OPINION

OPI 2021-2

Potential deficiency/discrepancy in the clause 3.1.3.5 Metal and inductive components-free space between wheels of the document ERA/ERTMS/033281 rev 4.0

REF.: Technical Opinion request for reviewing 'dynamic stimulation' and 'maximum width of 130 mm for magnetic track brakes' requirements from the ERA ERTMS interface document 2018 V4

Figure 5: Sensitive area

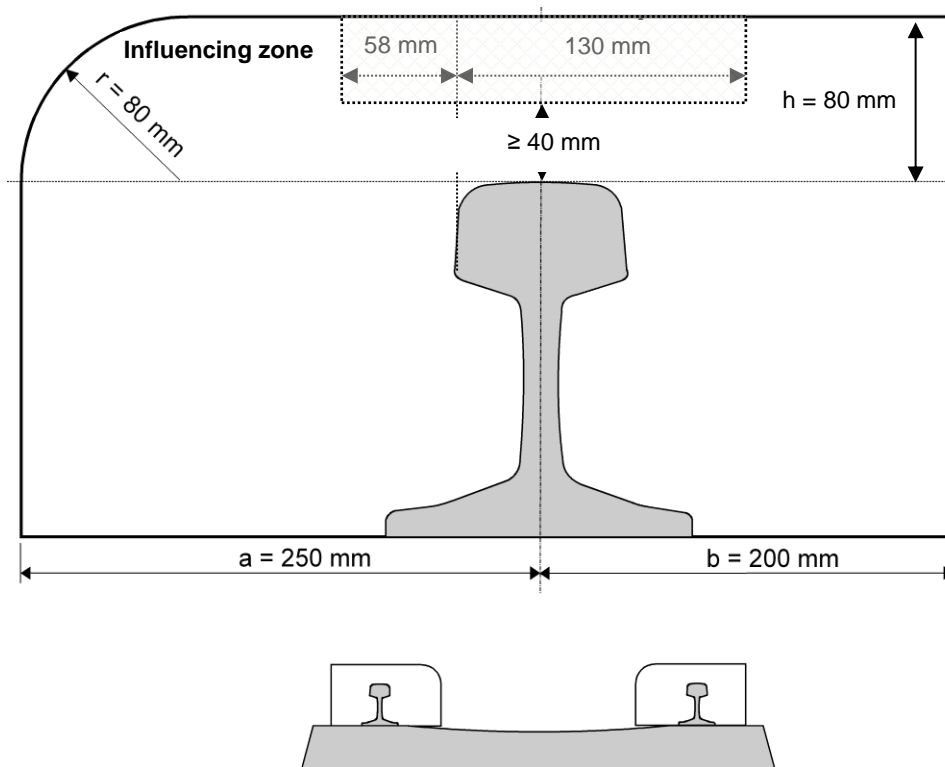
UNIFE remarked that the dynamic stimulation and that the presence of a metal part with the maximum width lateral dimension of 130mm inside the shaded area in §3.1.3.5 can be relaxed as specified in their solution proposal (see Annex 2 of the letter of UNIFE), so that they still meet the essential requirements concerning technical compatibility between vehicles and network (train detection systems).

In order to justify the relaxation of the dynamic stimulation and the presence of a metal part with the maximum width lateral dimension of 130mm inside the shaded area in §3.1.3.5, UNIFE refers in its letter to a performed stochastic analysis, where all relevant effects, which influence the vertical displacement have been taken into account. The effects have been categorized in adverse normal, increased and extreme range of magnitude and probabilities of each respective range have been determined/analysed. All the possible combinations of events and their added displacements have been determined by cumulation as well as the related likelihood. From all this, and as a result, a relation between displacement and likelihood has been derived.

The addressed problem by UNIFE including the proposed solution to lower the requirements related to dynamic stimulation and the presence of a metal part with the maximum width lateral dimension of 130mm inside the shaded area in §3.1.3.5 (in line with EN 16207:2014 setup and the solution proposal in Annex 2 of the UNIFE letter) was discussed during the ERA TDC Workgroup 56 at 26.02.2021. All experts agreed on this proposal.

Only wheels and their parts (gearboxes, brake parts) or non-metallic and non-inductive components are permitted to be mounted in the sensitive area of Figure 5.

Sanding pipes of sanding devices and rail guards are allowed to be mounted in a vertical (z-) distance ≥ 30 mm above the top of the rail. For sanding pipes below 40 mm to the top of the rail a maximum diameter of 60 mm is allowed.

Other metal parts (e.g. sanding pipe support, heating elements, magnetic brakes or eddy current brakes in rest position) are allowed to be mounted in a vertical distance ≥ 40 mm above the top of the rail. Inside of the shaded area in Figure 5, a metal part with the lateral dimension of maximum 130 mm and maximum 140 mm for magnetic track brakes, based on the dimensions of magnetic track brakes defined in EN 16207:2014, is allowed.

Magnets and wear pads for magnetic track brakes shall respect the dimensions as set out in EN 16207:2014, excerpt of chapter 5.5.2.

For magnetic track brakes or eddy current brakes in rest position, the vertical distance requirement (≥ 40 mm above the top of the rail) shall be met:

- Taking into account static vertical deflection of the running gear at maximum load
- With fully allowed wear of the wheel or the maximum wear of the wheel between two re-adjustments

For metal parts excluding magnetic track and eddy current brakes the vertical distance requirement shall be met:

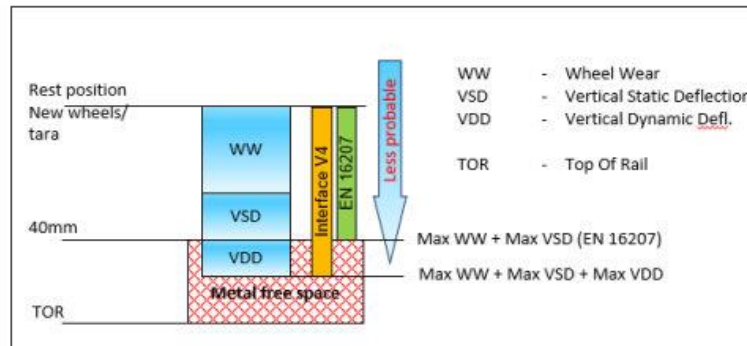
In the following diagram, the typical order of magnitude of some relevant influence effects is shown. The current technical rule in the actual ERA/ERMITS interface V4 setup leads to a very low displacement by considering maximum wheel wear and maximum vertical static deflection as well as a high value of vertical dynamic deflection ($\text{Max WW} + \text{Max VSD} + \text{Max VDD}$). In general, various individual influence effects add to a possible low displacement of the brake component. Apart from the lowering by wheel wear and spring deflection, there are even additional relevant influence effects, which raise the distance e.g. brake pad wear of magnetic track brakes or the influence of laminated coils for the eddy current brake.

Figure 5: Sensitive area

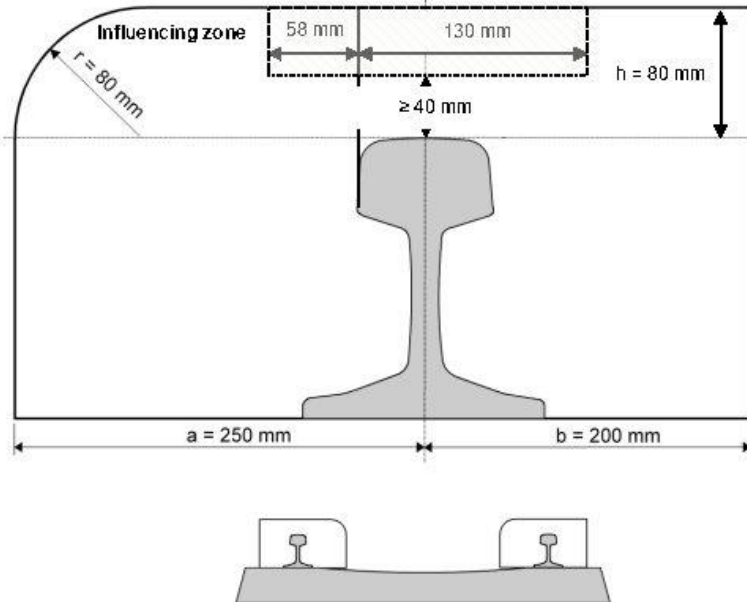
Annex-2 Proposal for revised text for §3.1.3.5 of ERA/ERTMS/033281 rev 4.0

(new/changed text underlined)

Only wheels and their parts (gearboxes, brake parts) or non-metallic and non-inductive components are permitted to be mounted in the sensitive area of Figure 5.

Sanding pipes of sanding devices and rail guards are allowed to be mounted in a vertical (z-) distance ≥ 30 mm above the top of the rail. For sanding pipes below 40 mm to the top of the rail a maximum diameter of 60 mm is allowed.

Other metal parts (e.g. sanding pipe support, heating elements, magnetic brakes or eddy current brakes in rest position) are allowed to be mounted in a vertical distance ≥ 40 mm above the top of the rail. Inside of the shaded area in Figure 5, a metal part with the lateral dimension of maximum 130 mm and maximum 140 mm for magnetic track brakes, based on the dimensions of magnetic track brakes defined in EN 16207:2014, is allowed.

End pieces for magnetic track brakes shall respect the dimensions as set out in Annex C of EN16207:2014 (see annex of this letter).

Magnets and wear pads for magnetic track brakes shall respect the dimensions as set out in EN 16207:2014, excerpt of chapter 5.5.2 (see annex of this letter).

For magnetic track brakes or eddy current brakes in rest position, the vertical distance requirement (≥ 40 mm above the top of the rail) shall be met:

- *Taking into account static vertical deflection of the running gear at maximum load*
- *With fully allowed wear of the wheel or the maximum wear of the wheel between two re-adjustments*

For metal parts excluding magnetic track and eddy current brakes the vertical distance requirement shall be met:

- *under all operational conditions (running in a curve, over switch, ...)*
- *for the maximum allowed wear of the wheel or the maximum wear of the wheel between two re-adjustments*
- *for the maximum spring compression of the primary and the secondary vehicle suspensions, considering:*
 - a. *static load*
 - b. *additional dynamic stimulation*
 - c. *tolerances of the stiffness*
- *for air springs the totally evacuation of the air-suspension bellow („emergency suspension“)*
